SAFETY ADVISORY # 12-186

Springdale Propane Line Relocation

Fig. 3

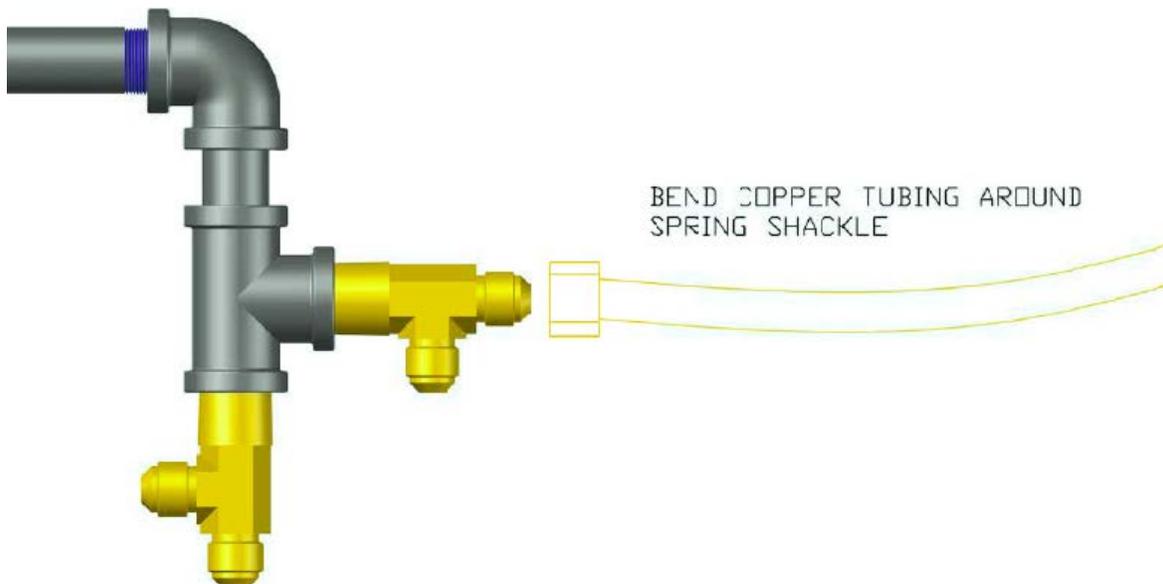
Keystone RV Company is conducting a voluntary RECALL notification campaign in accordance with the National Traffic and Motor Vehicle Safety Act. It has been decided the suspension may contact the copper propane line for the range. If the propane line is damaged and leaks in the presence of an ignition source, an increased risk of fire and/or explosion will result causing property damage and/or personal injury.

Remove the mounting clamps from the LP manifold to allow the manifold to hang loose so the end fitting can be removed and replaced. Disconnect the copper supply lines from the manifold. Remove the "T" fitting from the manifold. See figure 2 & 3.

Replace the "T" fitting with a 90 degree elbow pointed to the center of the unit. Add a 1/2" close pipe nipple to the elbow. Reinstall the "T" fitting to pipe nipple as shown in Figure 2. Relocate the copper lines to reconnect to manifold. See figure 2 & 3.
